1. SUBMITTAL TYPE: (Is this a resubmittal? Yes ☐ No ☒)			
Deferred Submittal ☐	Addendum Number: 01	Revision Number:	CCD Number: Category A ☐ or B ☐
2. PROJECT INFORMATION:			
School District/Owner: San Beranrdo City USD		DSA File Number: 36 H7	
Project Name/School: Indian Springs HS - Health Center		DSA Application Number 04 123900

ADDENDUM NO. 1

Indian Springs High School – Health Center

DSA #04-123900 FILE #36-H7 RCA Project No. 1-78-50

GRADING PLAN

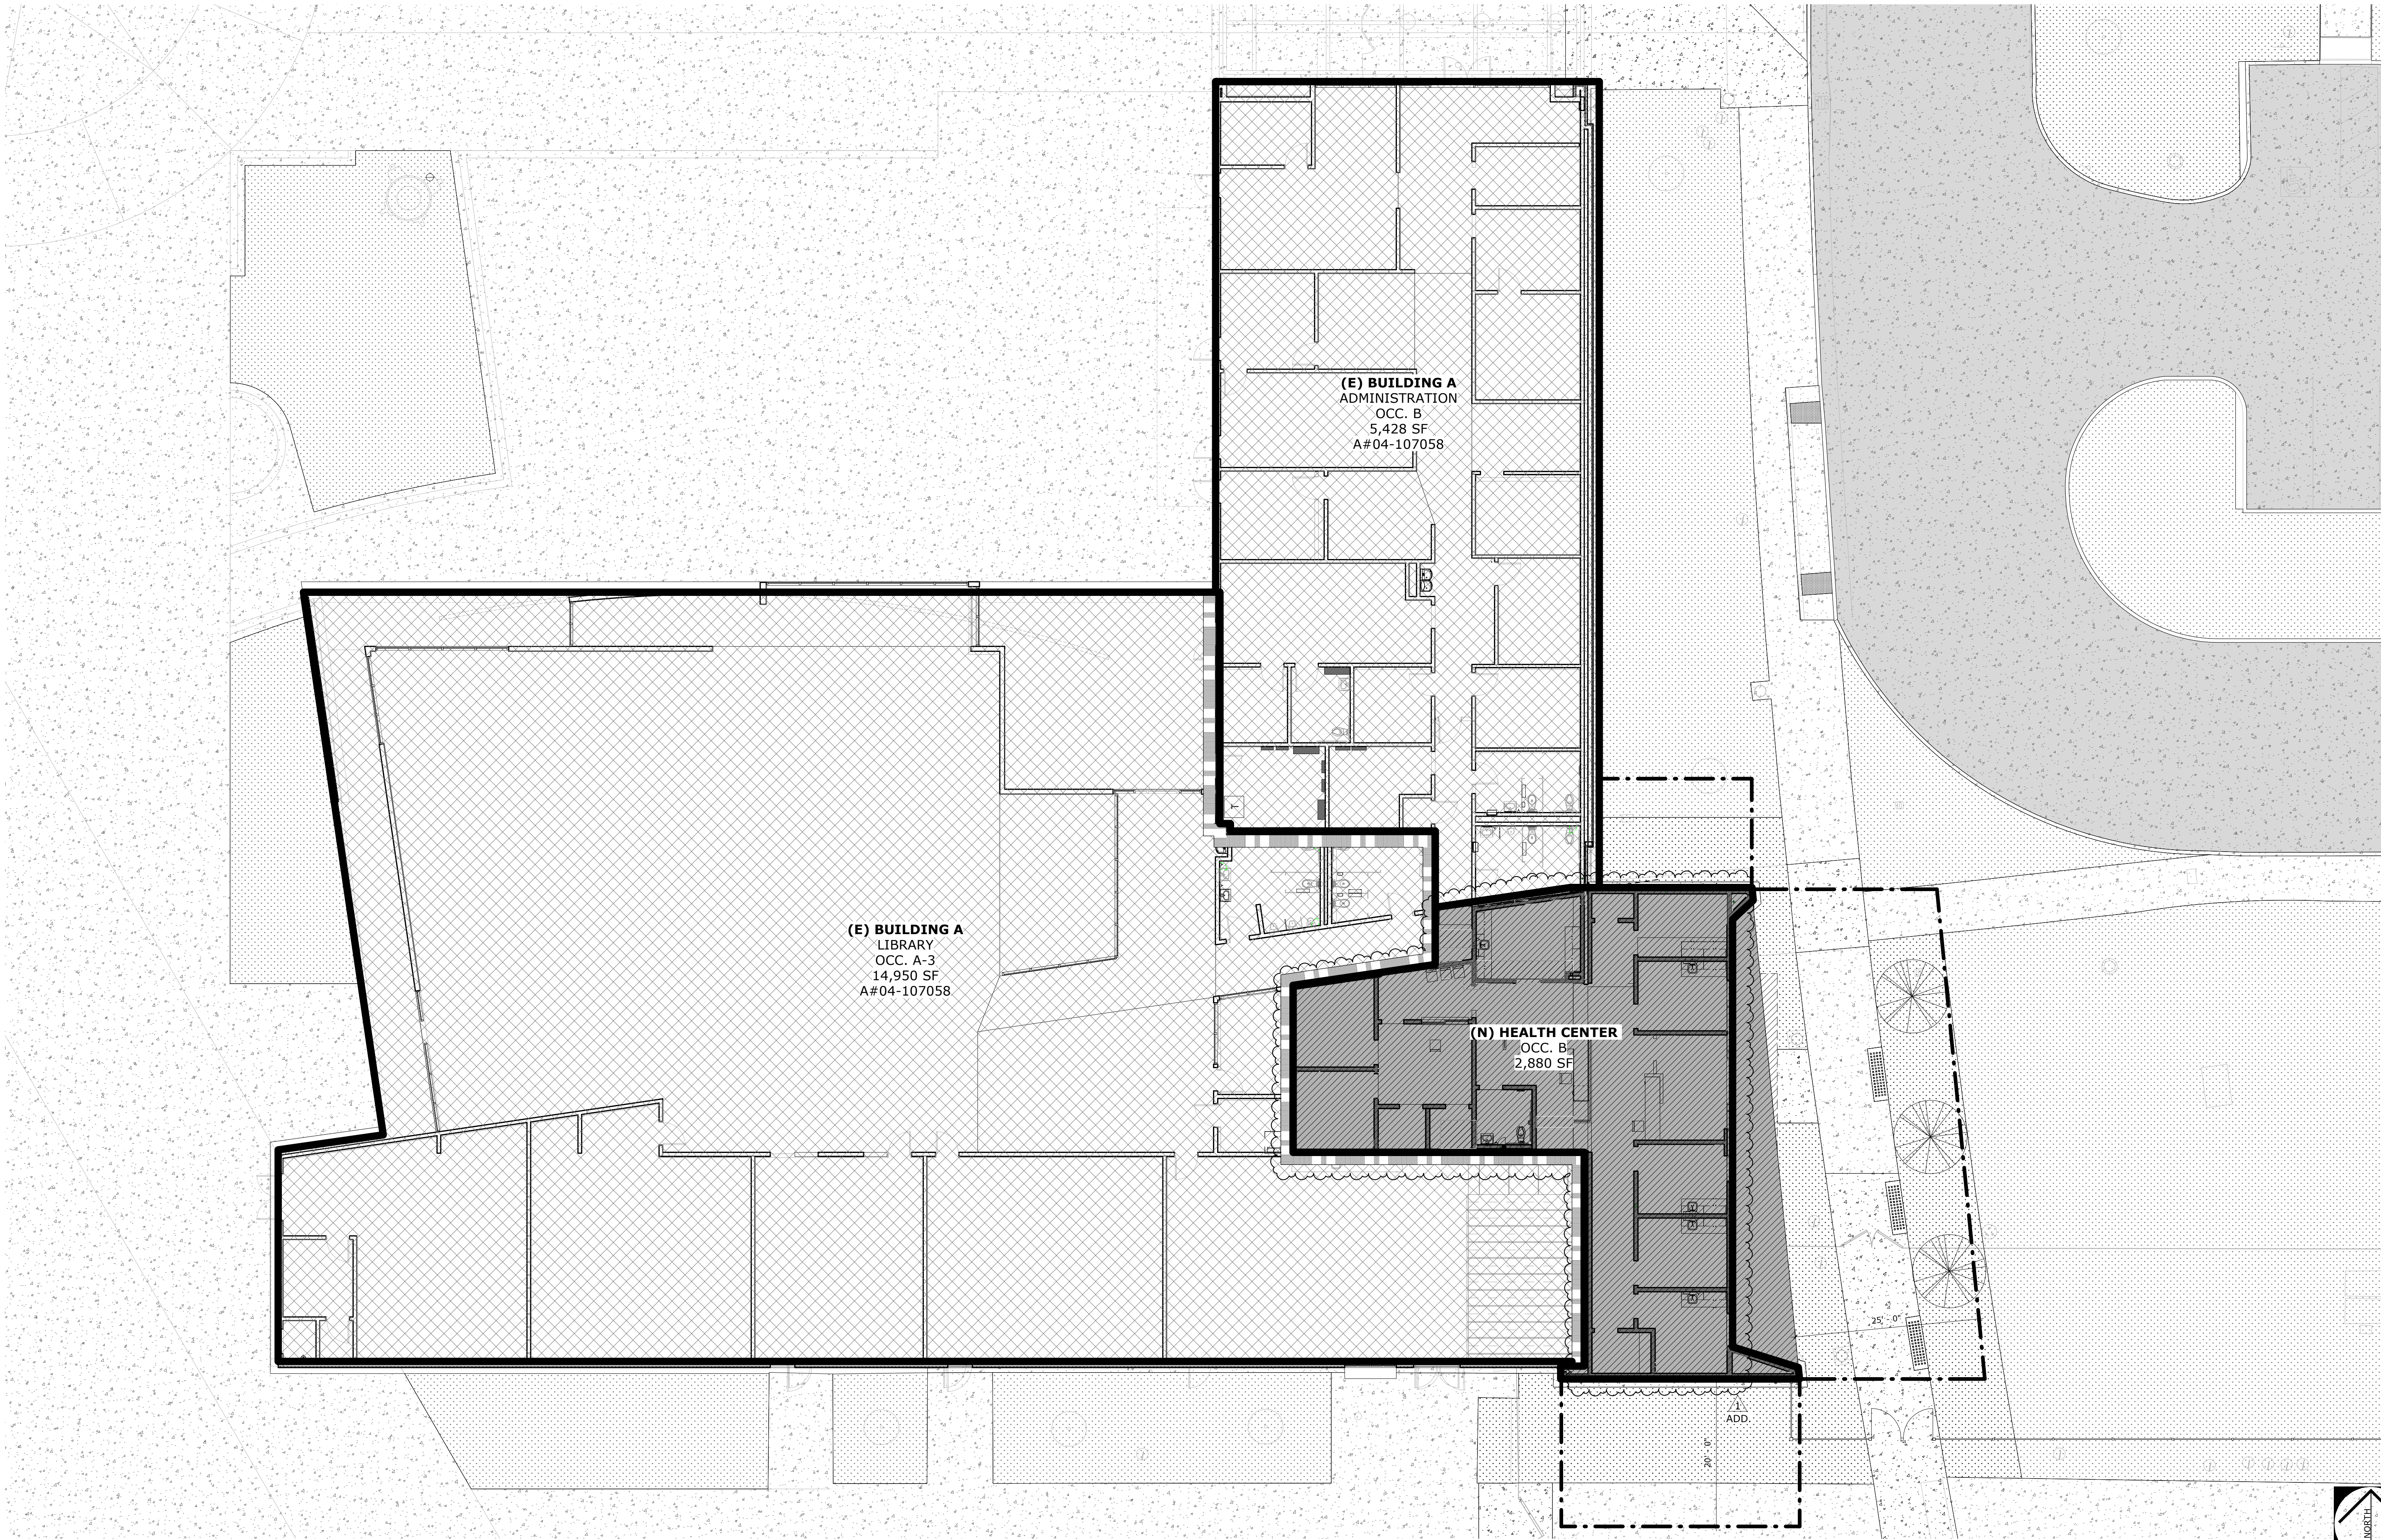
| Item No. 1.6 | Reference Sheet C-3.0 – GRADING PLAN |
| 1.6.1 | Replace Sheet C-3.0 and revise per clouded areas & items listed below: |
| | (a) Revised grading (per new topographic survey) at New Passenger Drop Off in front of Existing Building 'B' |

DEMO & NEW FLOOR PLANS

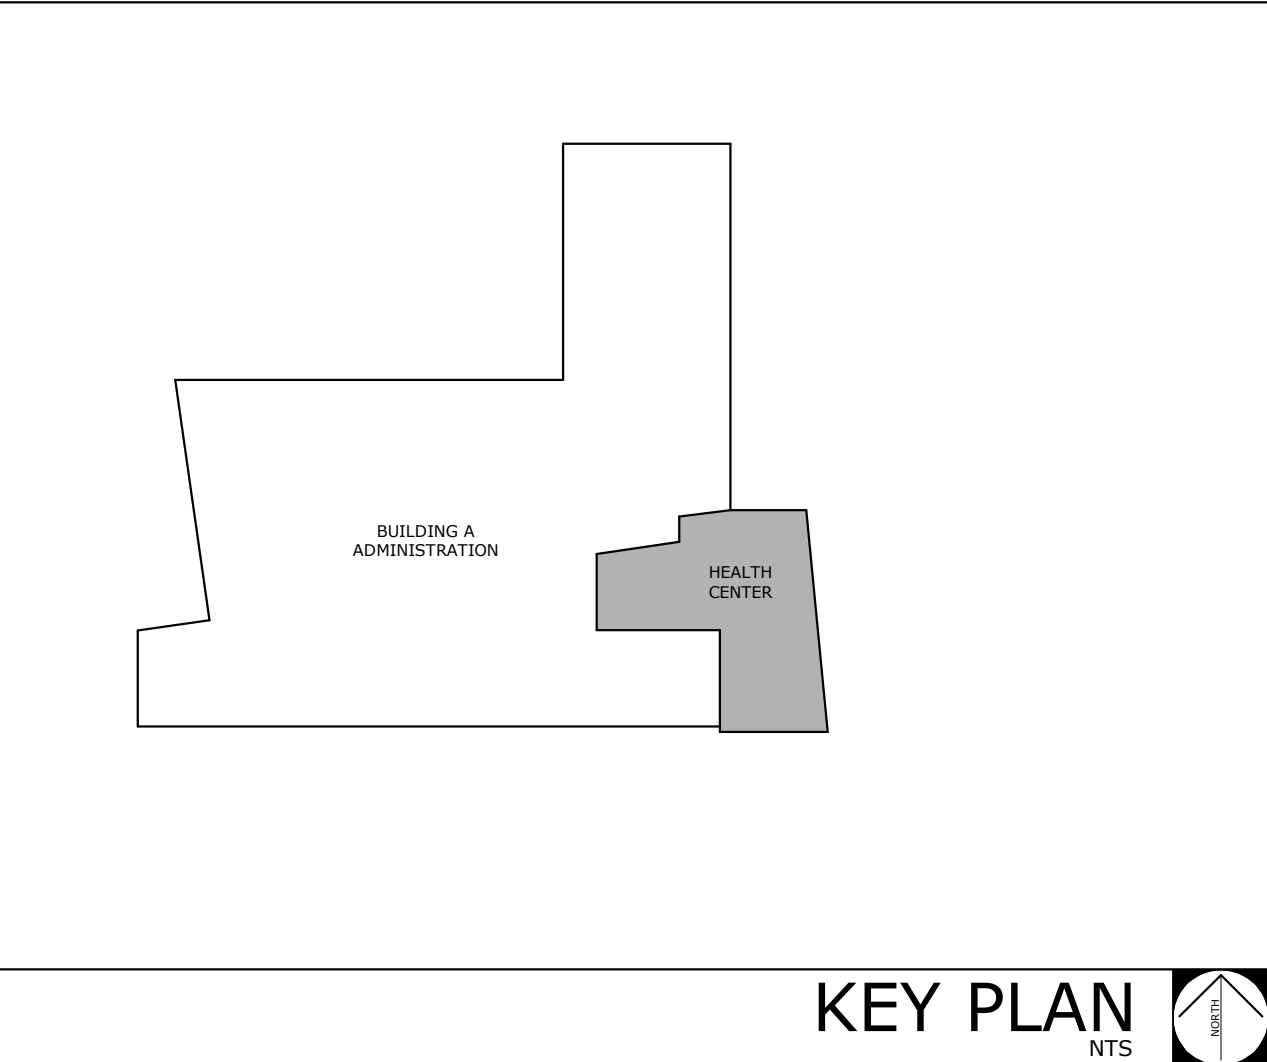
- Item No. 1.9 Reference Sheet A1-1.0 – DEMO & NEW FLOOR PLANS
1.9.1 Replace Sheet A1-1.0 and revise per clouded areas & items listed below:
 (a) Detail 1, Revised floor plan layout

(b) Detail 2, revised existing slab removals based on updated MEP layouts
- Item No. 1.10 Reference Sheet A1-2.0 – DEMO & NEW RCP
1.10.1 Replace Sheet A1-2.0 and revise per clouded areas & items listed below:

W215-0 SCALE: NO SCALE HOLDOWN ANCHORS 6

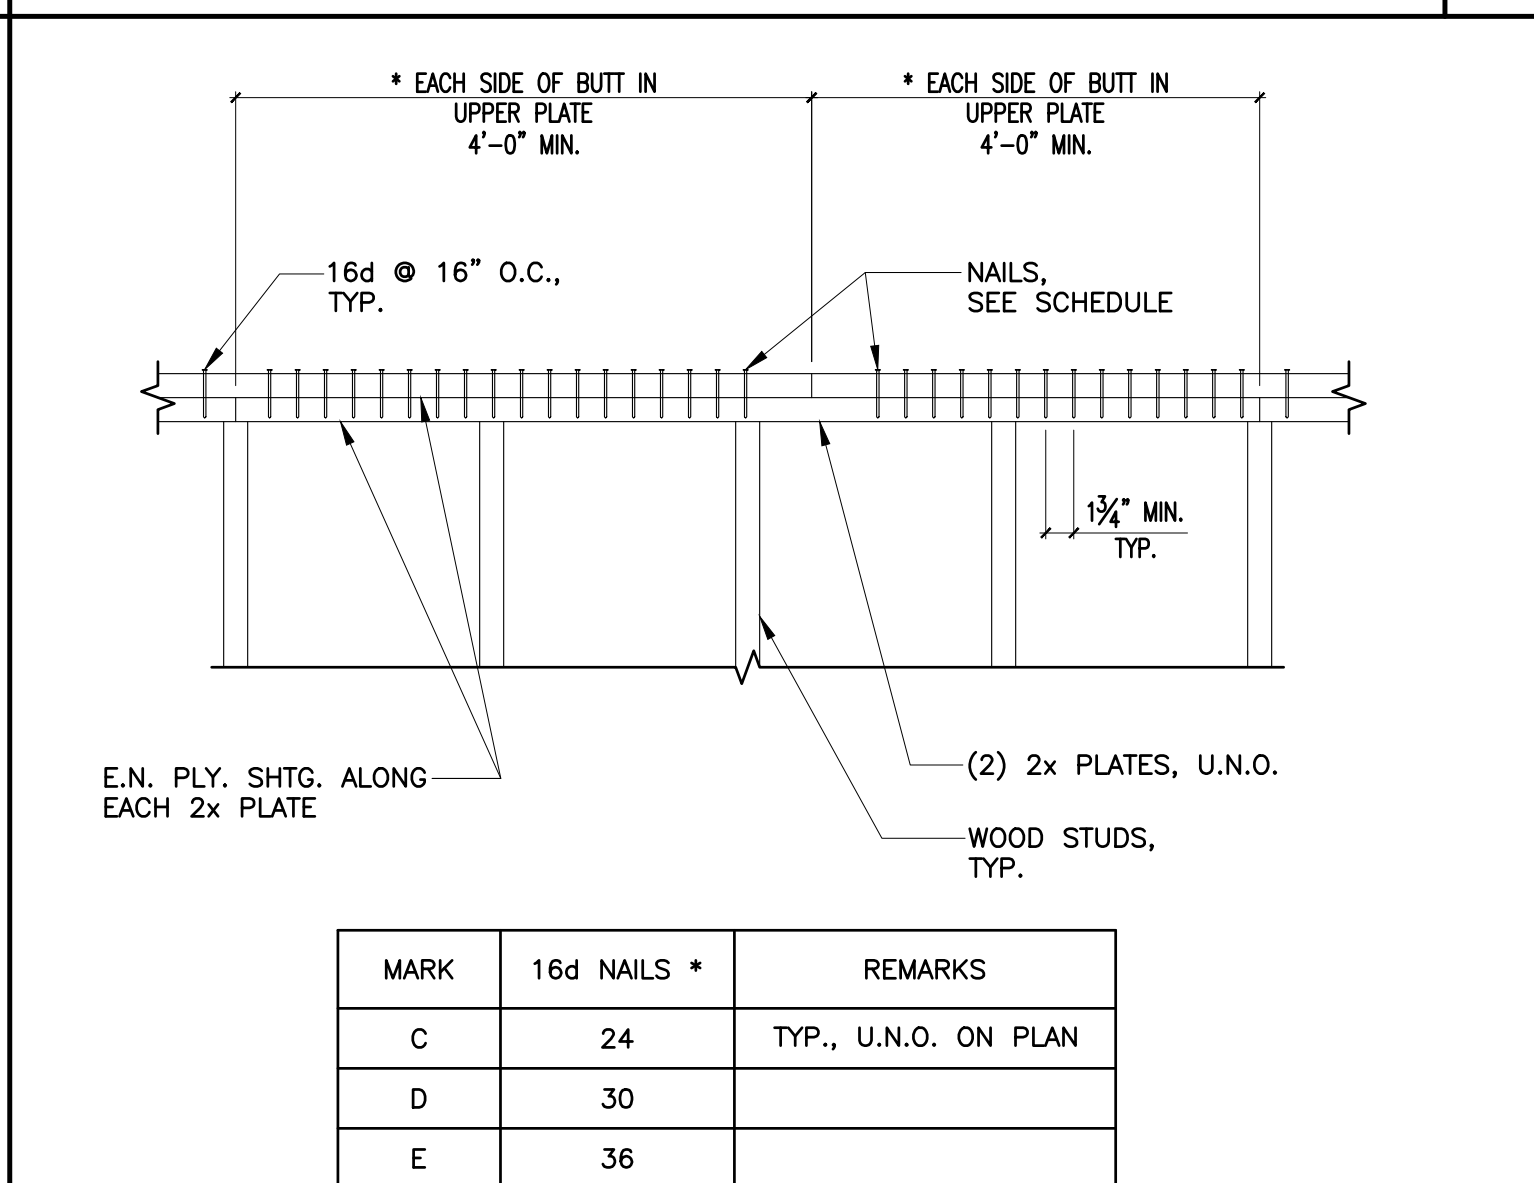
- Item No. 1.22 Reference Sheet S0-2.4 - TYPICAL WOOD DETAILS
- 1.22.1 Replace Sheet S0-2.4 and revise per clouded areas & items listed below:
- (a) Detail 6, revise Holdown Anchor Schedule

FOUNDATION PLAN NOTES

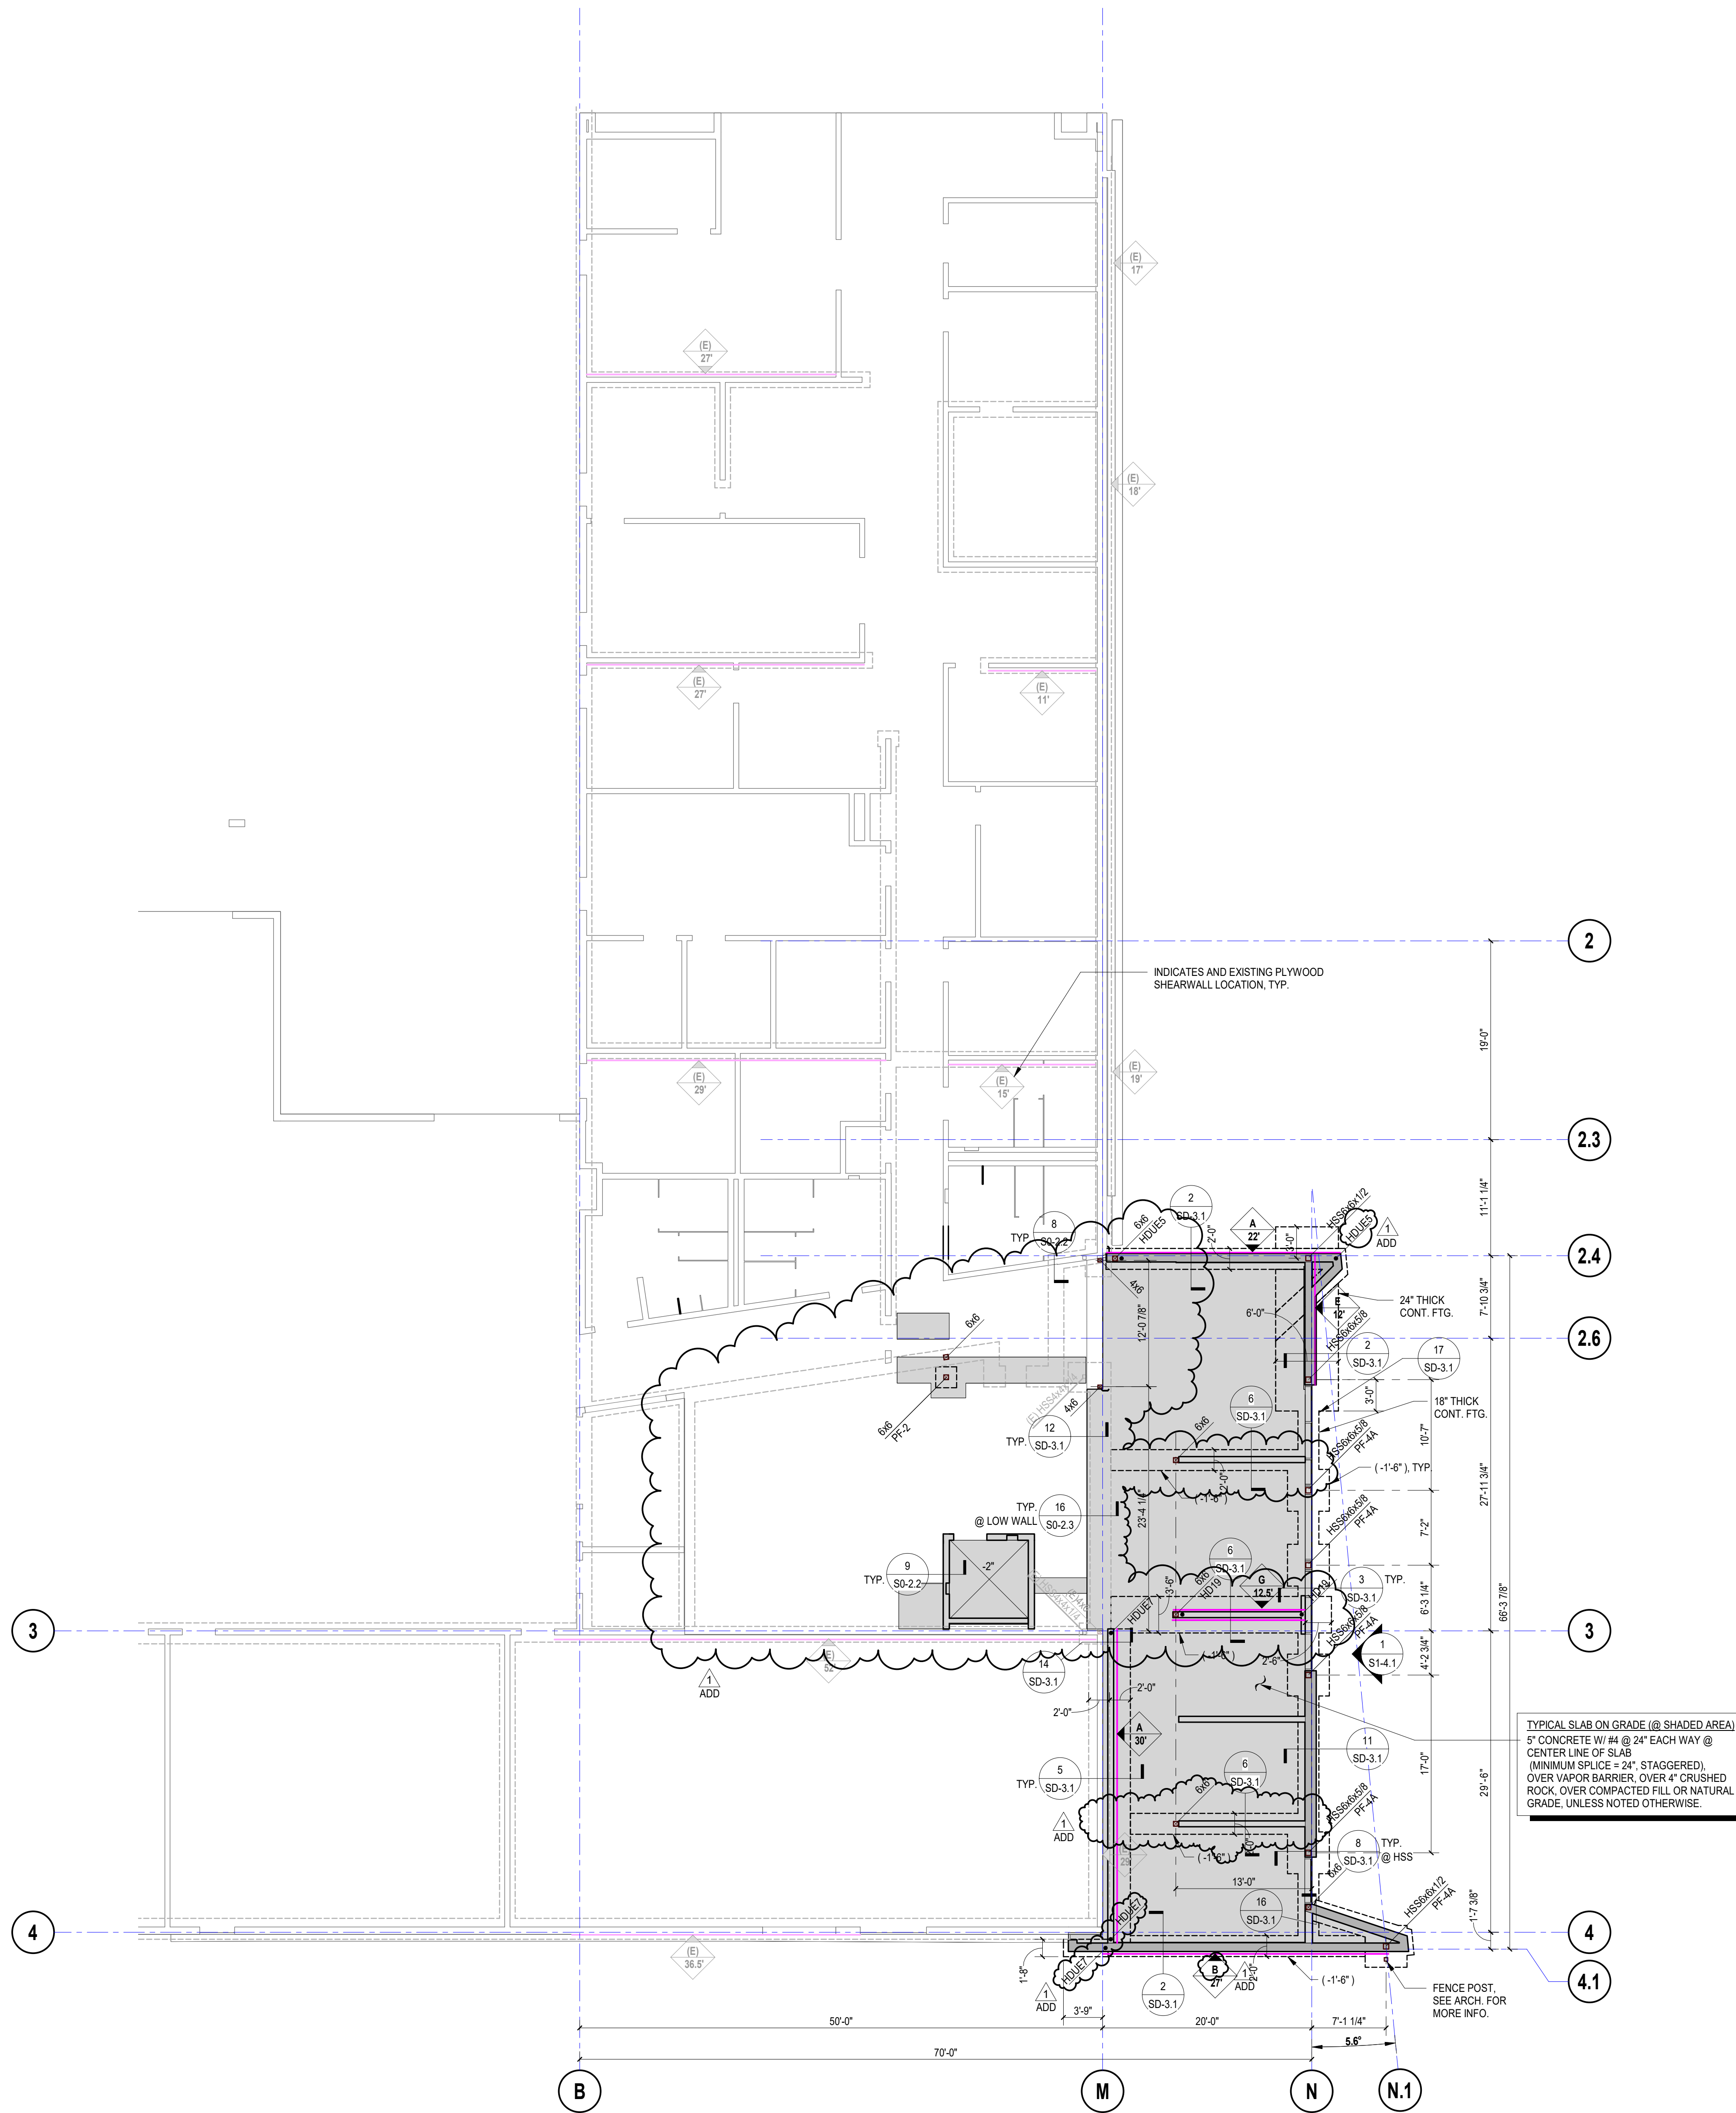
- Item No. 1.23 Reference Sheet S1-1.1 - FOUNDATION PLAN
- 1.23.1 Replace Sheet S1-1.1 and revise per clouded areas & items listed below:
- (a) Revised Foundation Plan in coordination with Architectural changes
